From: Lauren Griffin
Sent: Monday 11 November 2024 16:39
To: [REDACTED]
Subject: RE: Ref. No: ABP - 320938 - 24- Woodquay Park Enhancement - Galway City Council

I wish to object to the proposed development for the following reasons

LAYOUT PLAN

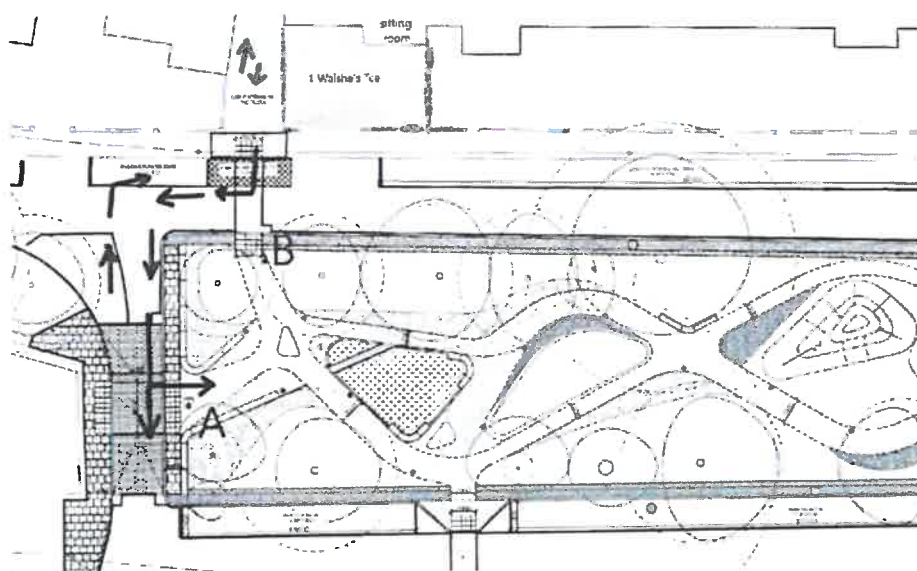
1) Reduction in amenity and loss of privacy at my dwelling house. The proposed new entrance at B (see layout plan below) opposite the front entrance to my house reduces the residential amenity of my dwelling as it overlooks the front of my house and represents a significant reduction in privacy. I am accustomed to people passing my house and that's fine but under this proposal they will be looking straight at my front door, sitting room and driveway. Essentially all activity, coming and going can be observed from close range in a manner it couldn't be heretofore. There is absolutely no need for this new entrance to the Park while there is an alternative major new proposed entrance located a few meters around the corner looking onto the waterside and the river Corrib. The consultants response to this issue is in the Consultants Report as follows

The elimination of the proposed entrance opposite my private residence (See B below) does NOT CHANGE or contradict any of the provisions cited for creating the proposed entrance at B. The "key linkage" is still maintained using the proposed new entrance yards away facing the water. I strongly believe that if it was a private body that made the planning application to a Local Authority they would be conditioned to relocate the entrance so as to protect me from injurious affection and to protect my residential amenity.

Therefore I am requesting that the proposed opening be omitted.

Blue arrows indicate Existing 2 way cycle and pedestrian movements to and from The Plots which is located at the rear of my dwelling and through the laneway at the side of my house. All that is required is that Park entry be at Point A and the "key linkage" planning criteria will still be maintained.
